Addendum No. 001

**Subject: Cooling Plant Replacement
SDP Contracts No. B-080C, B-081C and B-082 of 2017/18**

**Location: Thomas A. Edison High School
151 W Luzerne Street
Philadelphia, Pennsylvania 19140**

This Addendum, dated August 9, 2018, shall modify and become part of the Contract Documents for the work of this project. Any items not mentioned herein, or affected by, shall be performed strictly in accordance with the original documents.

A.01

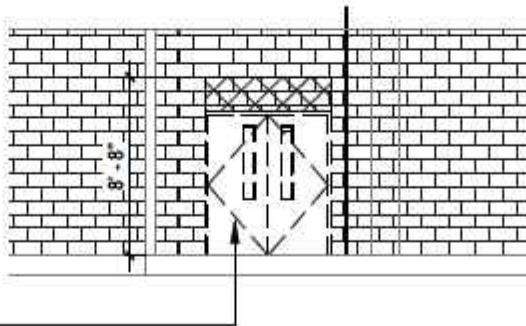
- **Modified** detail 3 to remove additional blocking above the door frame to make for a larger opening. Refer to addendum Sketch A.01
- **Modified** detail 4 to remove additional blocking above the door frame to make for a larger opening. Refer to addendum Sketch A.01

M.01

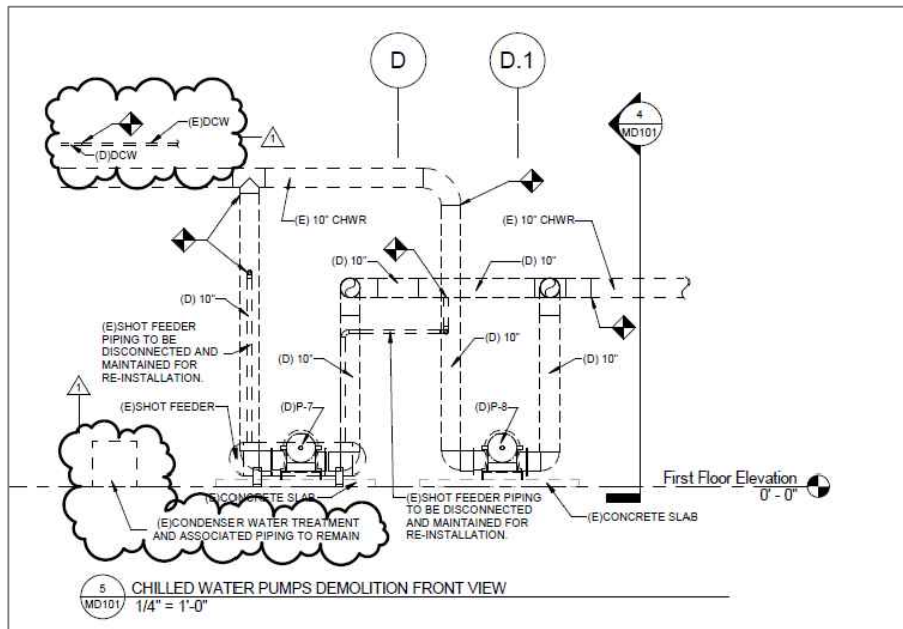
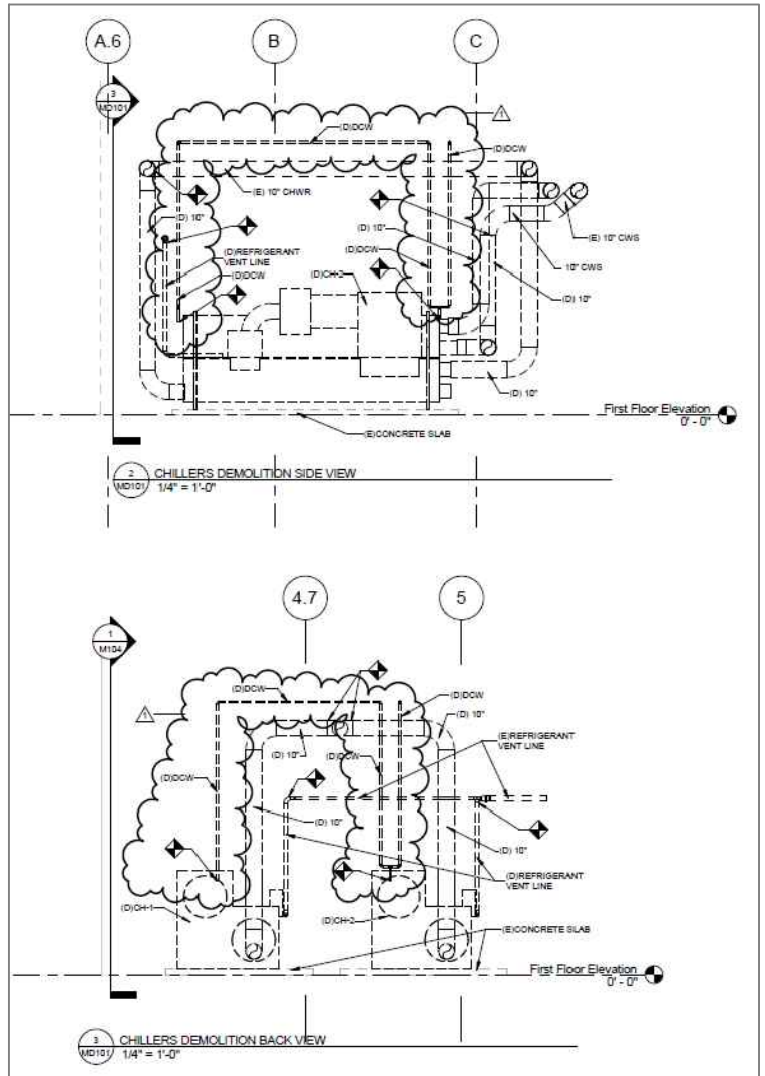
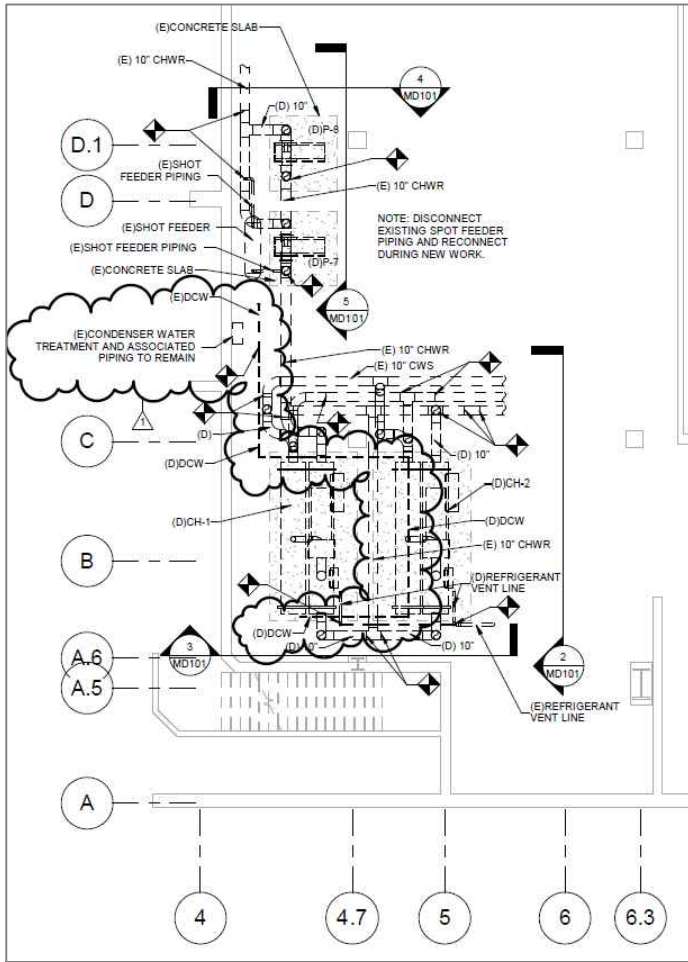
- **Added** condenser water treatment equipment and associated piping to remain to both plan and section views on drawing (piping not shown on drawing), Refer to addendum Sketch M.01
- **Added** domestic cold-water piping to both plan and section views on drawing, Refer to addendum Sketch M.01

M.02

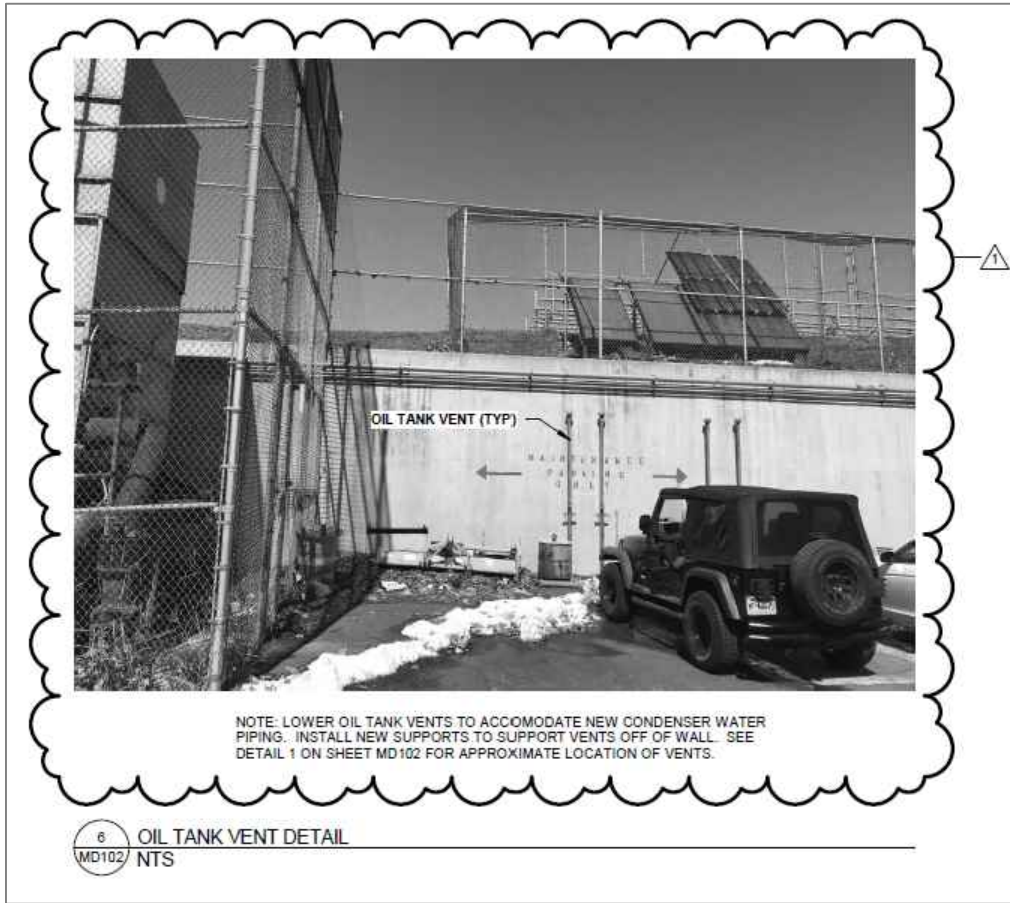
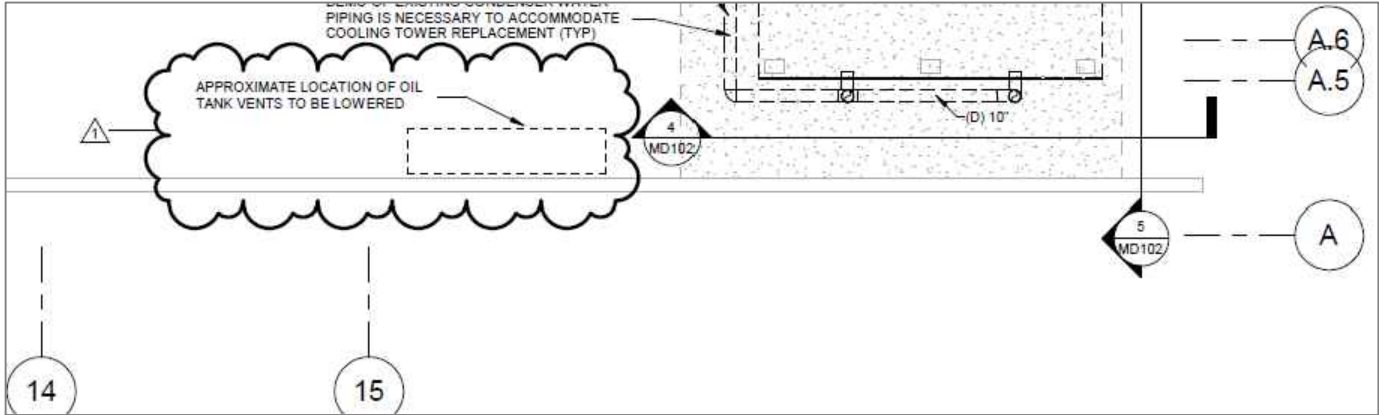
- **Added** detail 6 to show oil tank vents that need to be lowered. Refer to addendum Sketch M.02
- **Added** approximate location of oil tank vents to detail 1 plan view, Refer to addendum Sketch M.02

10. On M102, there is a note to lower (4) existing oil tank vents, work not shown. Can a section view or picture be provided to clarify scope? Are there new supports required? Is there wall restoration to be done?

Answer: Refer to Detail 6/MD102.

M.03

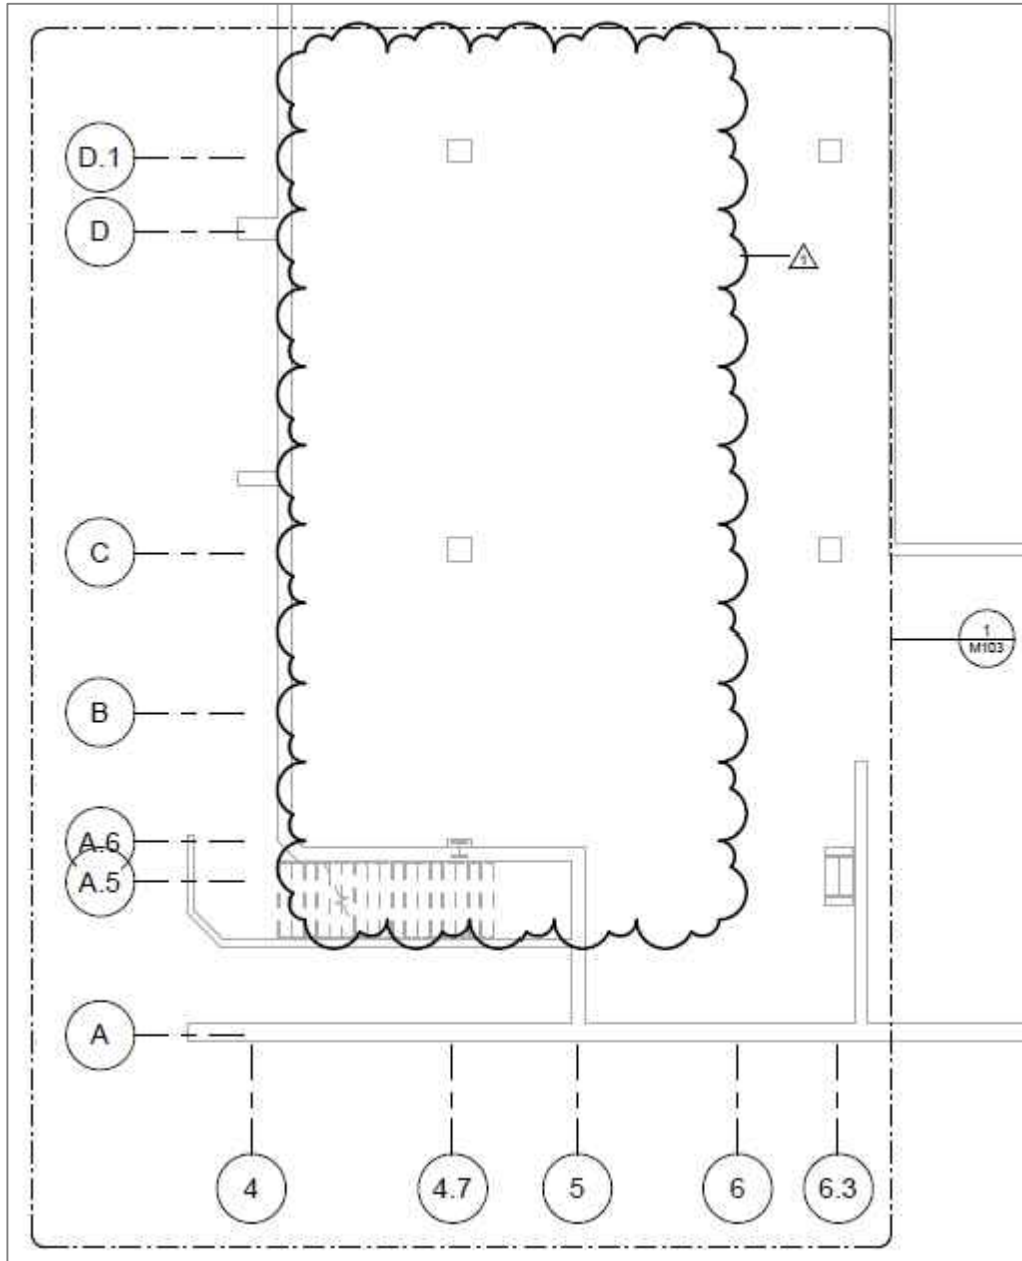
- **Removed** clouded elements from drawing for clarity. All necessary information is shown on Sheet M103, Detail 1, Refer to addendum Sketch M.03

DRAWING NO.
M.04

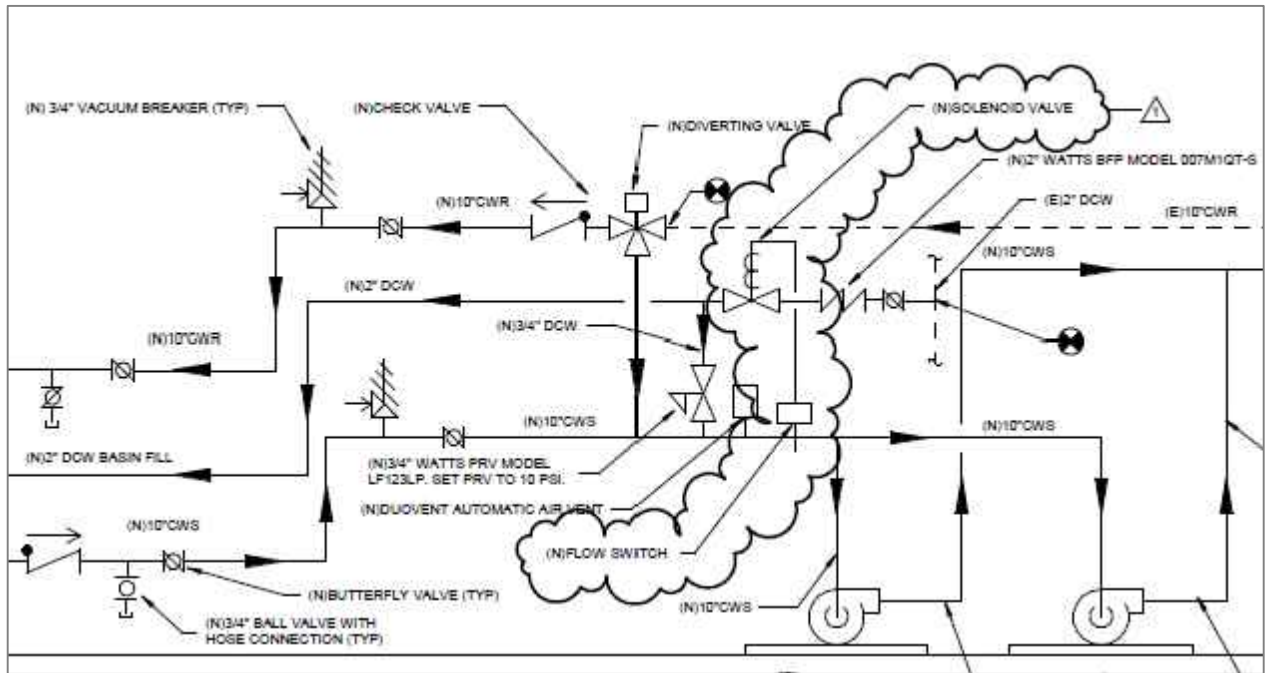
- **Added** flow switch and solenoid valve to Chiller Piping Diagram, Refer to addendum Sketch M.04

DRAWING NO.
M.05

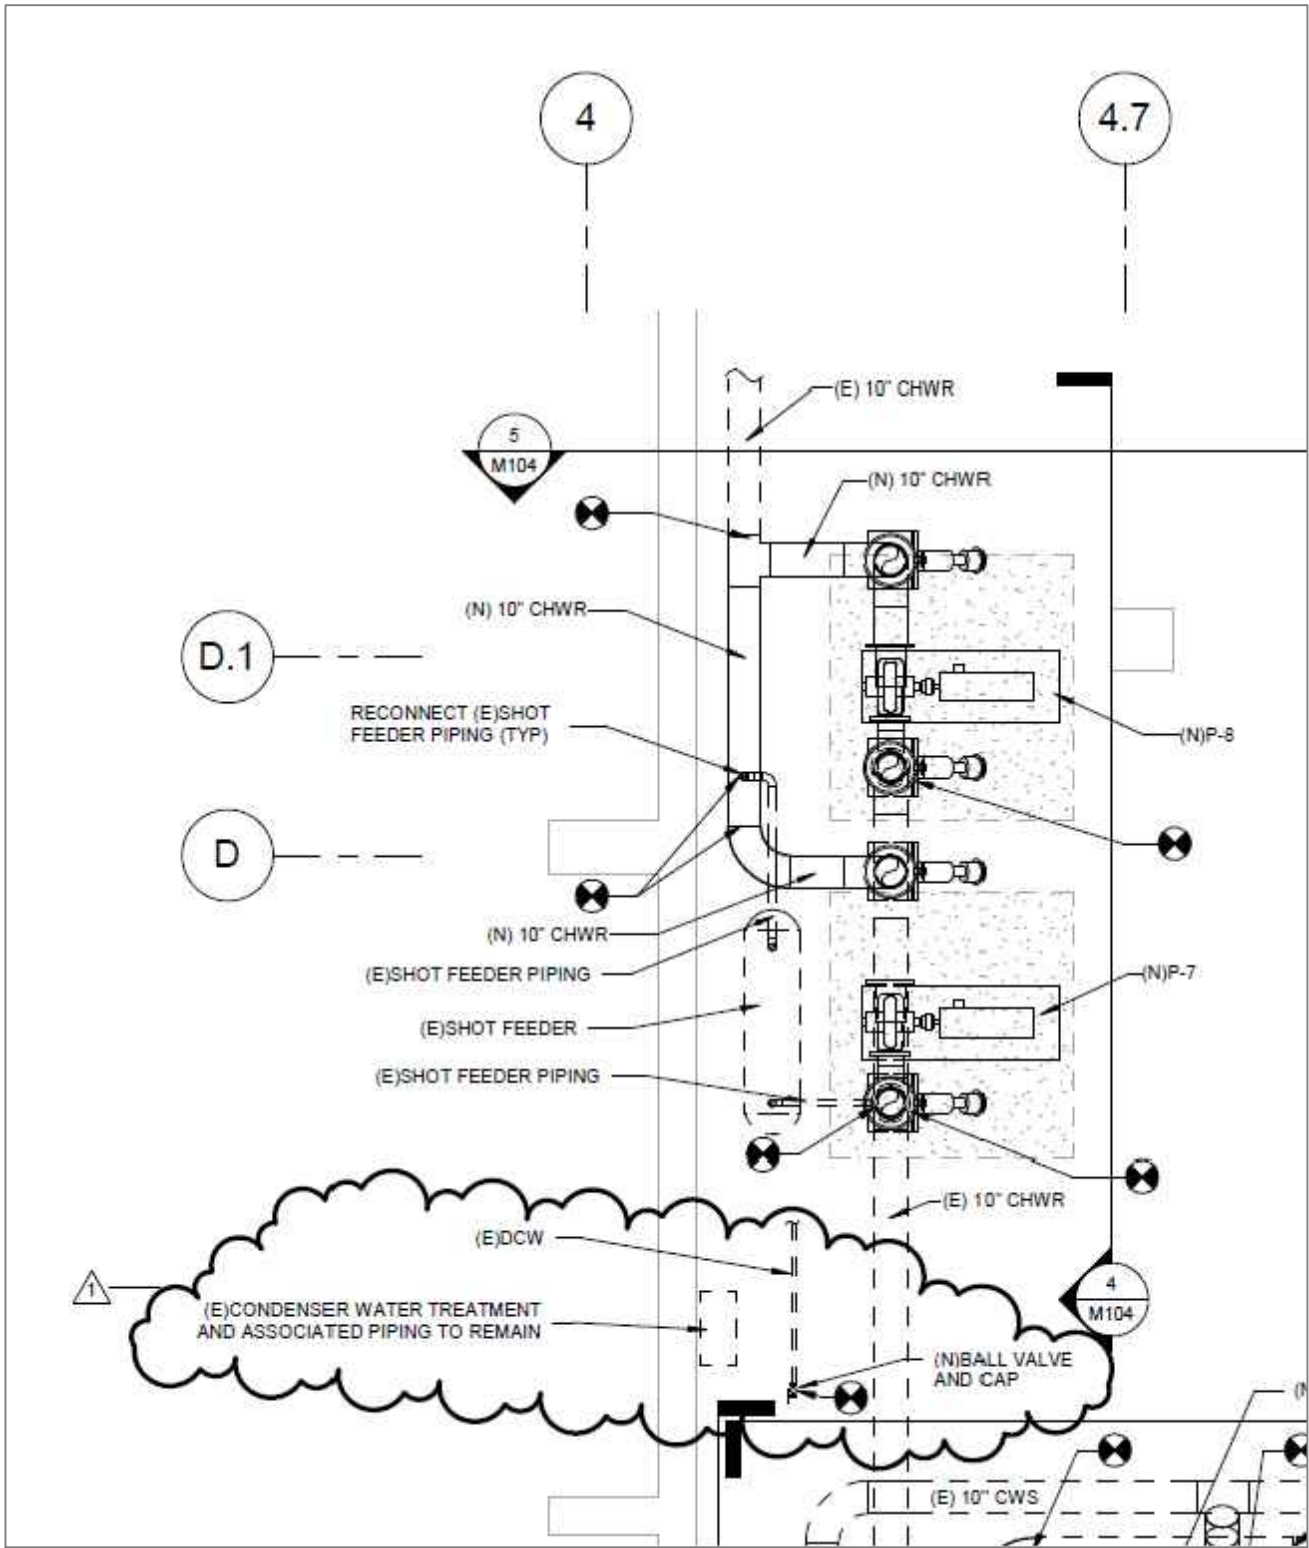
- **Added** condenser water treatment equipment and associated piping to remain to plan view on drawing (piping not shown on drawing), Refer to addendum Sketch M.05
- **Added** domestic cold-water piping and new ball valve to plan view on drawing, Refer addendum Sketch M.05

M.08

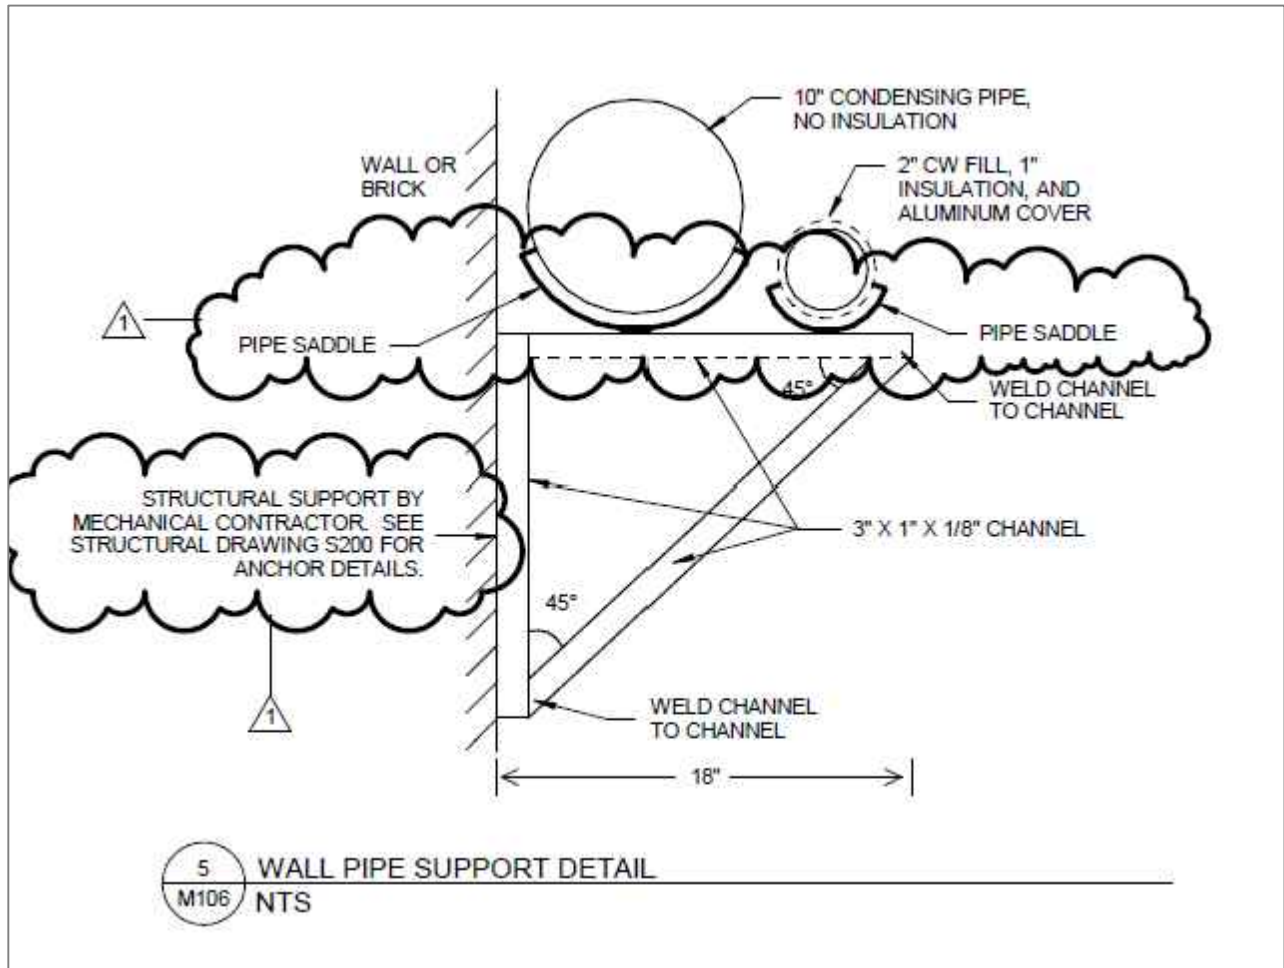
- **Added** pipe saddles and modified note on wall support detail #5, Refer to addendum Sketch M.08

9. Does any insulation require jacketing?

Answer: The outdoor domestic water piping serving the Cooling Tower Basin Fill is to be insulated and provided with an aluminum jacket per detail 5/M106.

E:01

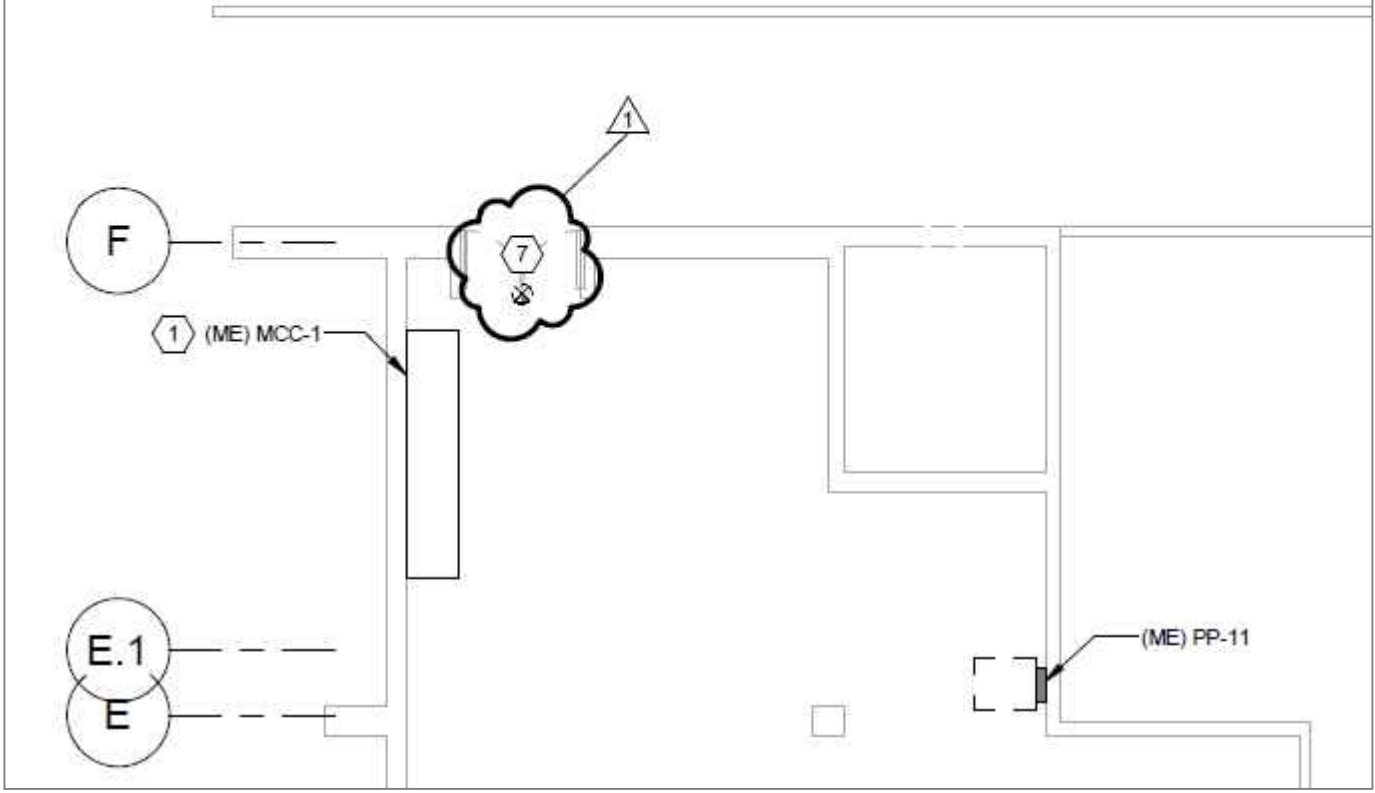
- **Added** existing exit sign at the end of the mechanical room to drawing, Refer to addendum Sketch E.01
- **Added** Keynote #7 addressing work on existing exit sign, Refer to addendum Sketch E.01
